PSE IRP Consultation Update

Webinar 4: Demand-side resources

8/04/2020

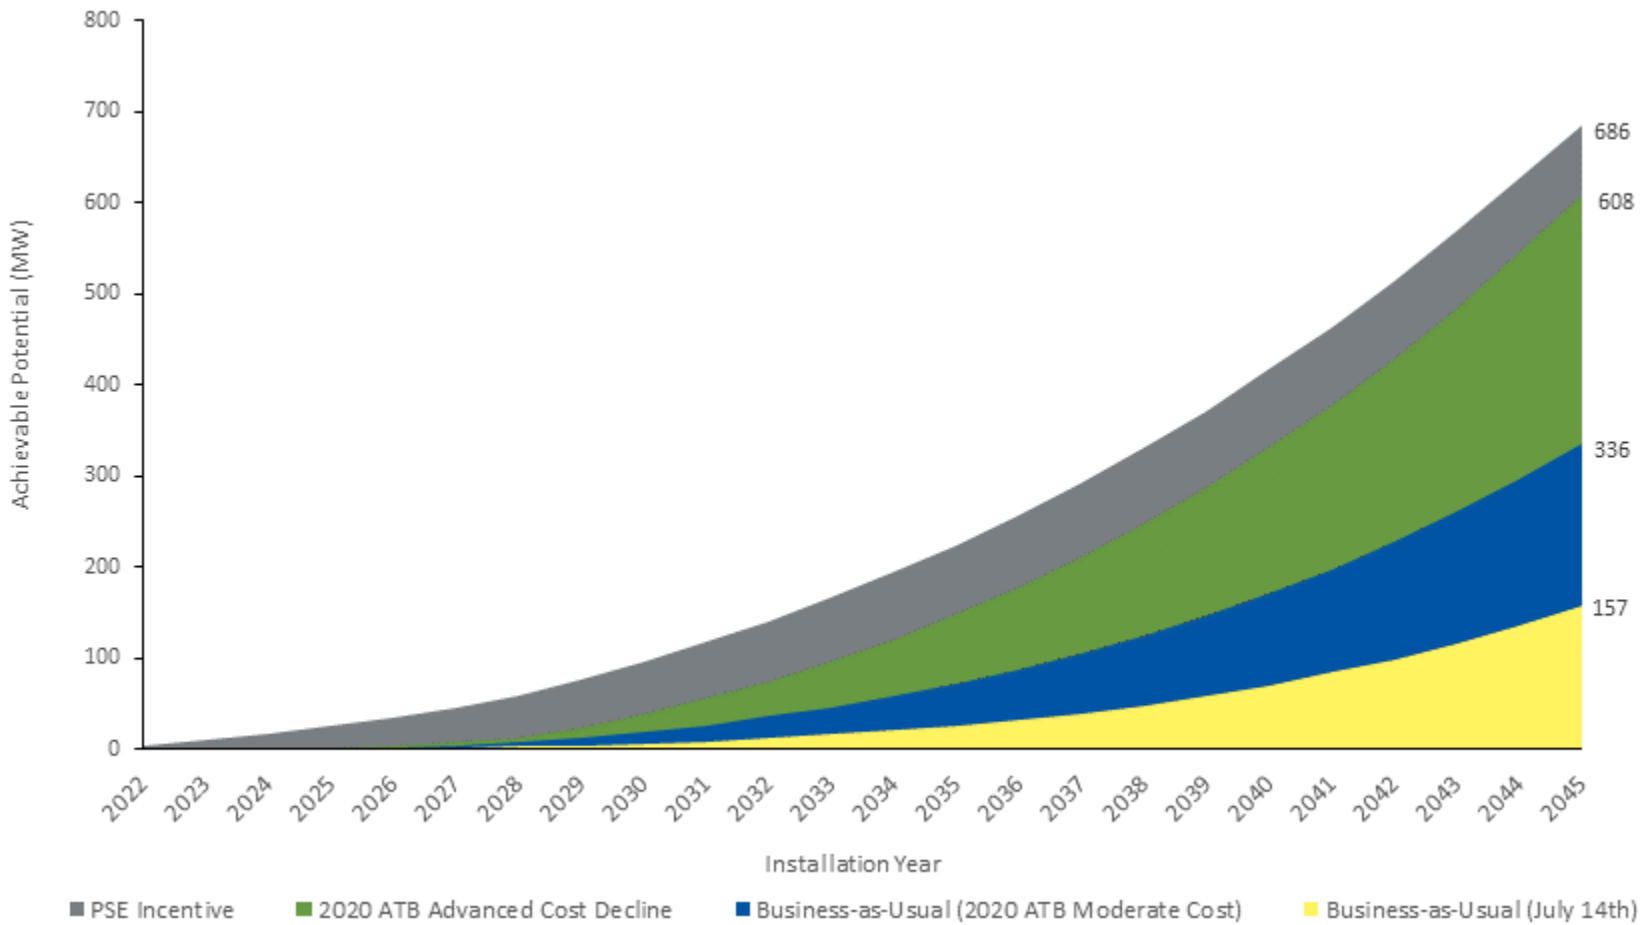
PSE received feedback from Fred Heutte (NVEC) and Kyle Frankiewich (WUTC) that the cost curve was not up to date, and that a sensitivity should be considered with a lower cost curve. Fred referenced to the recently released (July 2020) 2020 ATB data from NREL.

Cadmus had used the 2019 ATB data in their webinar slide, and has since updated the distributed solar pv market potential using the 2020 ATB data. As NVEC had suggested the costs are lower.

The figure below shows the results. The business as usual (BAU) case, which represents the current net metering program, updated with the 2020 MTB *Moderate* Cost forecast, now shows 24-year cumulative potential of 336 MW, which is about 10% higher than the program’s straight line projection of 300 MW, which was shown in the August 14 webinar.

Furthermore, the 2020 ATB *Advanced* Cost Decline forecast shows 24-year cumulative potential of 608 MW.

1. Update the business as usual (BAU) case to the 2020 ATB *Moderate* Cost forecast, and
2. Replace the PSE incentive sensitivity with the 2020 ATB *Advanced* Cost decline as the sensitivity
